Department of Environmental Quality
Division of Radiation Control

May 23, 2003

SUBJECT: Response to DOE May 13, 2003 Letter Regarding Final Site Observational Work Plan for the Green River, Utah UMTRA Site

Figure 5-6. Orientation of Fracturing and Joints at the Green River Site

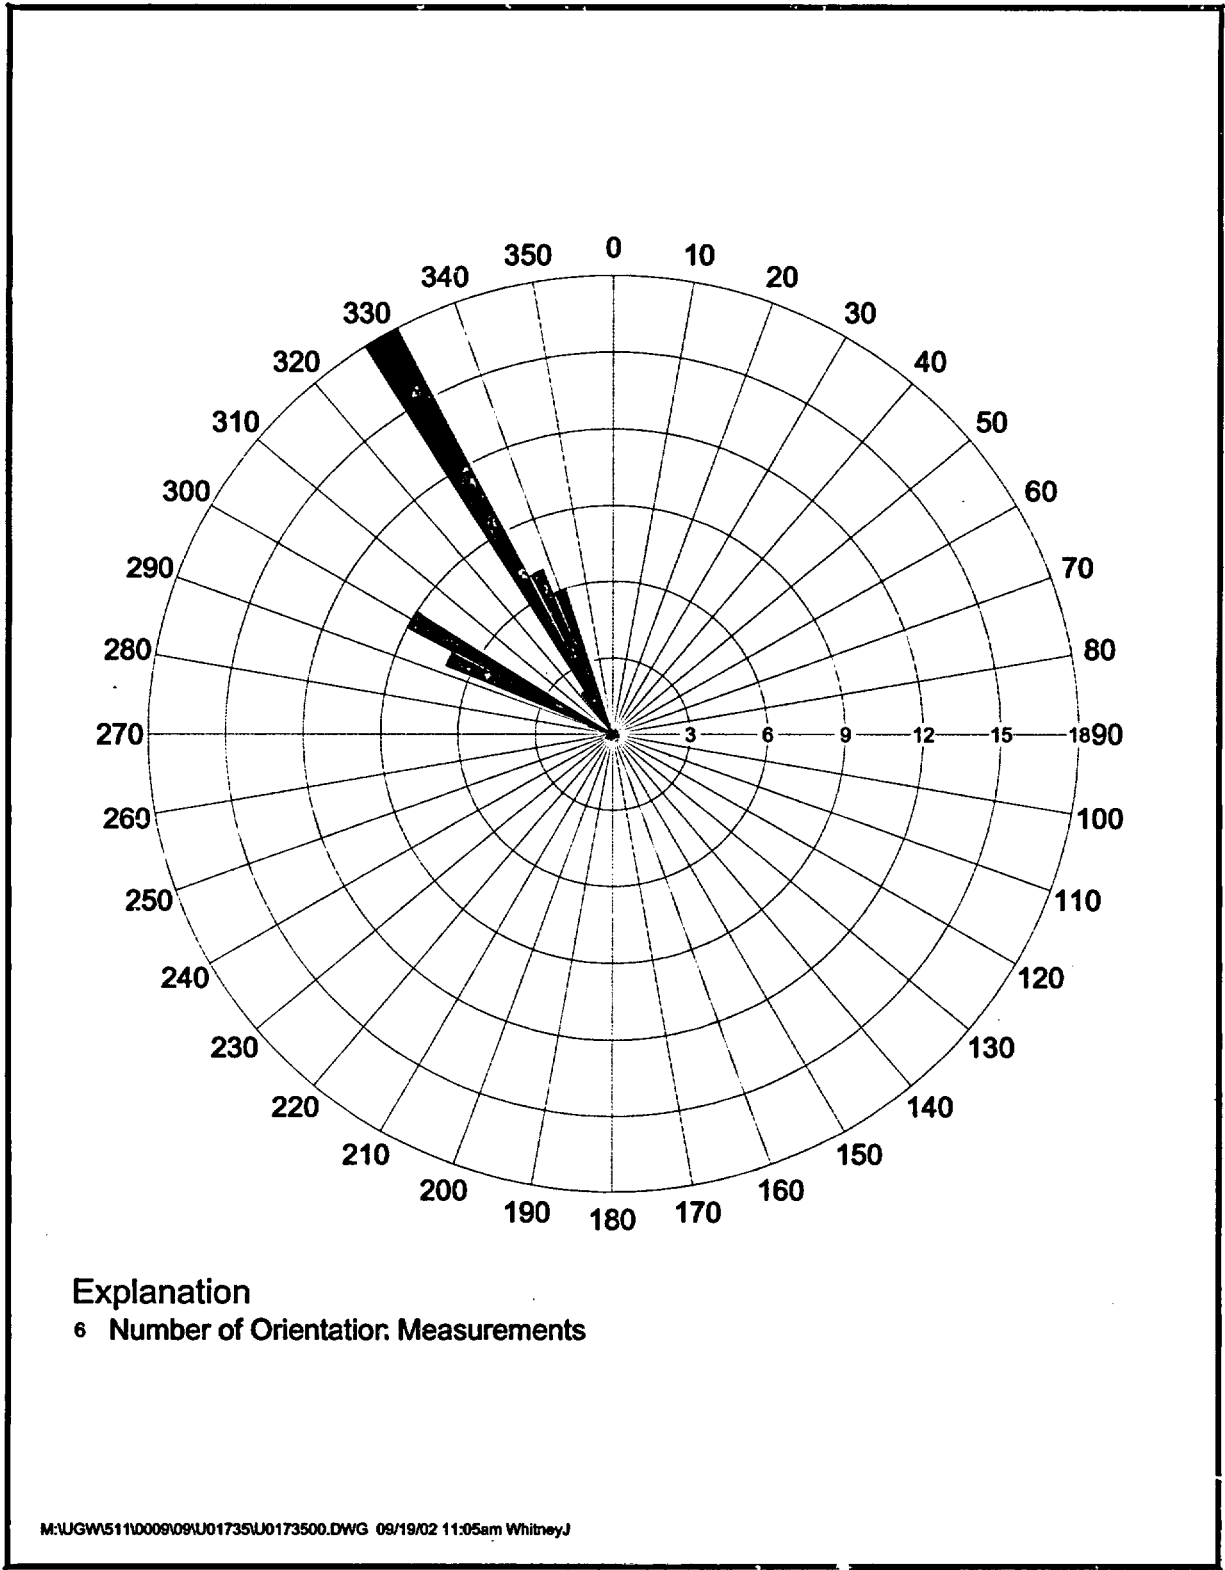
Fractures Patterns and Structural Dip. As indicated in Figure 5-6 of the Final SOWP, fracture and joint patterns have a predominant northwest orientation (Attachment 2). In addition, a structure contour map for the top of the middle sandstone unit indicates a northern structural gradient with a slight northwest dip component in the vicinity of the disposal cell (Attachment 3).
